## **MCCORD-HAMILTON SUBDIVISION,** **RESUBDIVISION OF LOT 2**

APPLICATION NUMBER 1 DATE July 10, 2008

REQUEST Subdivision

# DETAIL SITE PLAN

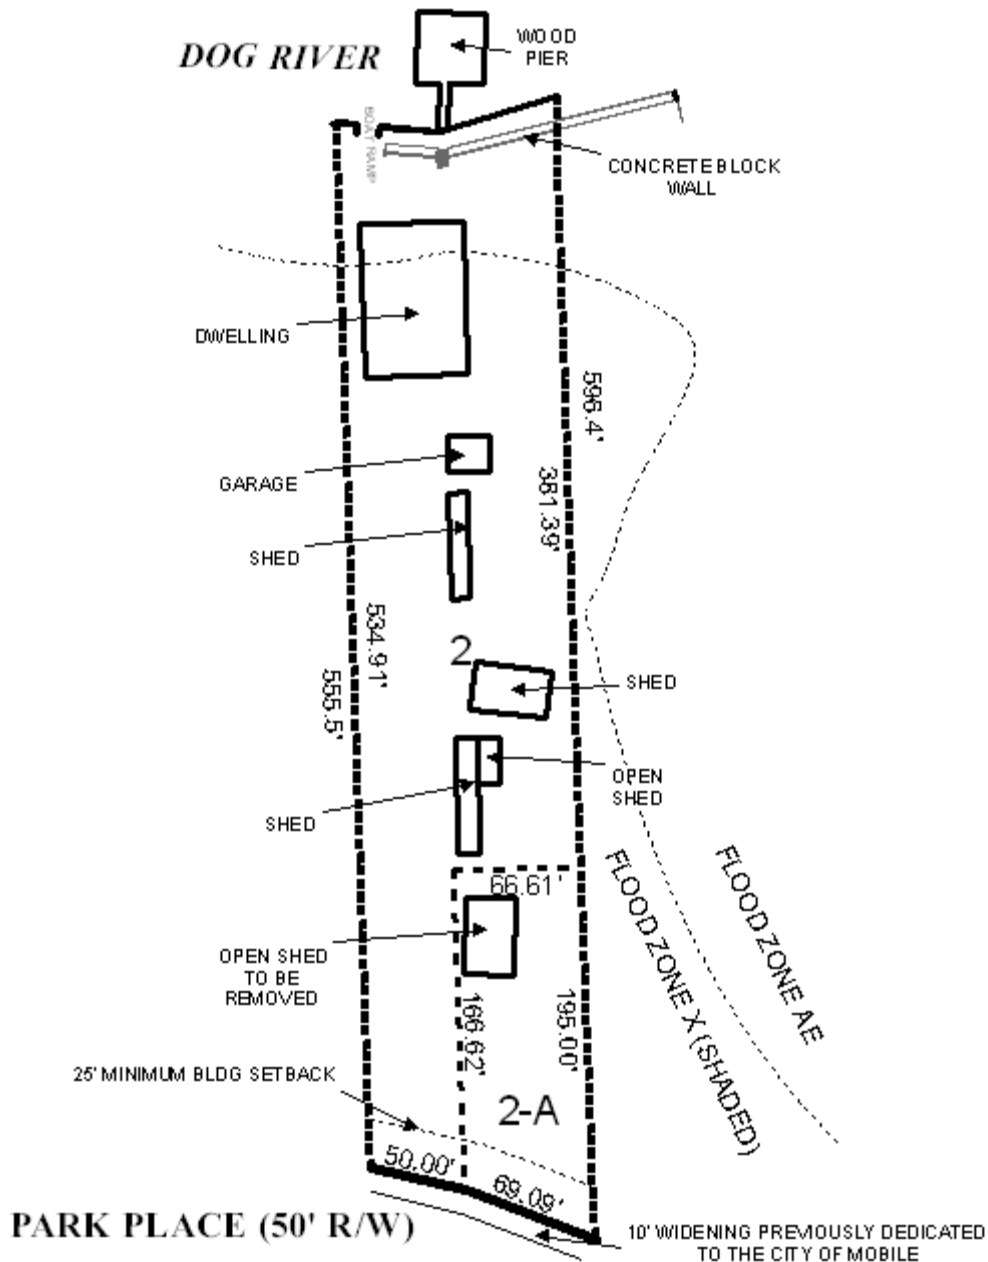
The 25-foot minimum building setback line is depicted on the preliminary plat, however the setback line should be adjusted for the proposed flag lot, if approved, to depict the setback line at least 25-feet from where the “pole” meets the “flag” portion of the lot. It appears that an existing accessory structure will fall within the flag-lot minimum building setback line, thus the accessory structure should be modified, moved or demolished (with appropriate permits) so that it is not within the required building setback line, prior to the signing of the final plat.

An accessory structure exists on proposed Lot 2 A. As accessory structures are not allowed without a primary residence on the same lot within the City of Mobile, the accessory structure should be removed (with appropriate permits) prior to the signing of the final plat.

- 1) Revision of the plat to depict all existing structures, including the metal garage that was permitted in October 2007, or provision of a statement indicating that the garage was not built; and
- 2) Provision of justification for a flag-lot, via evidence of other legal flag-lots in the vicinity, or other flag-parcels predating the applicability of the Subdivision Regulations.

*A revised plat was provided indicating all existing structures, including the 24 X 40 foot metal garage. The applicant also provided evidence of nearby subdivisions approved by the Planning Commission which include “flag” lots.*

- 1) Revision of the plat to depict the 25-foot minimum building setback line for proposed Lot 2 from where the "pole" meets the "flag" portion of the lot;*

- 2) The removal, modification or demolition of any existing accessory structures that fall within the minimum building setback line required by condition # 1, with appropriate permits, prior to the signing of the final plat;*

- 8) Removal of the existing accessory structure on Lot 2 A (with appropriate permits) prior to the signing of the final plat; and*
- 9) Full compliance with Engineering comments, and placement of those comments as a note on the final plat (Show Minimum Finished Floor Elevation (FFE) on plans and plat for all lots located within the X-Shaded and AE Flood Zones. Must comply with all storm water and flood control ordinances. Cannot concentrate storm water runoff to an adjacent property without a release agreement or a private drainage easement. Any work performed in the right of way will require a right of way permit.).*
